August 8, 2024

URGENT FIELD SAFETY NOTICE
THIS IS AN UPDATE TO PREVIOUSLY INITIATED ACTIONS for
FSCAs

MAQUET CARDIOSAVE Hybrid and MAQUET CARDIOSAVE Rescue

Figure 1: Instructions for identifying your IABP device’s current Software Revision.

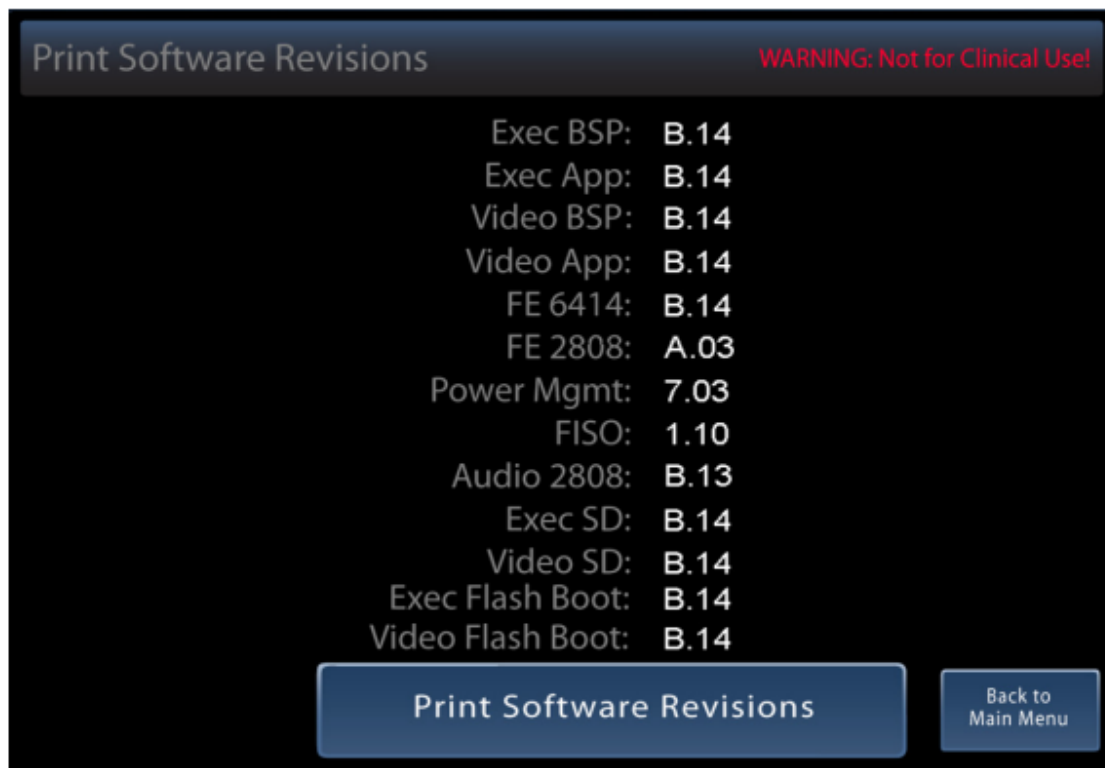
1. Examine your inventory immediately to determine if you have any Cardiosave Hybrid and/or Rescue IABPs.
2. Identify the Software Revision currently installed on your affected devices. Refer to Figure 1 below for instructions on how to identify the revision of software currently installed on your device.
 - If each of your affected devices have software revision D.00 or D.01, your devices have been corrected for purposes of the above Field Safety Corrective Actions.

- i. Getinge/Datascope sent a separate Field Safety Corrective Action notice to customers on March 29, 2024 (FSCA 2249723-11/16/2022-001-C) regarding the potential for blood to enter into the Cardiosave Hybrid and Rescue IABPs, for which software revision D.01 was released as a correction. D.01 contains each of the corrective updates from D.00 and adds the correction for a blood back event.
- If any of your devices have software revision lower than D.00 or D.01 (e.g.: B.XX or C.XX), your device still requires the software update and has not yet been corrected.

3. If your device has not been corrected with the updated Software Revision, **please continue to follow the instructions as listed in the original notifications until your devices have had their software updated.** Please contact your local Getinge Representative if you need an additional copy of the original notifications.
4. Complete and sign the attached Response Form (Page 5) to acknowledge that you have received and understand this notification. Return the completed form to Datascope/Getinge by e-mailing a scanned copy or by faxing the form to your local Datascope/Getinge Representative or office.
5. Datascope/Getinge service representative will contact you to schedule the installation of the updated software. You may also contact your local Getinge Service representative at 6296 1992. This work is being done at no cost to your facility.
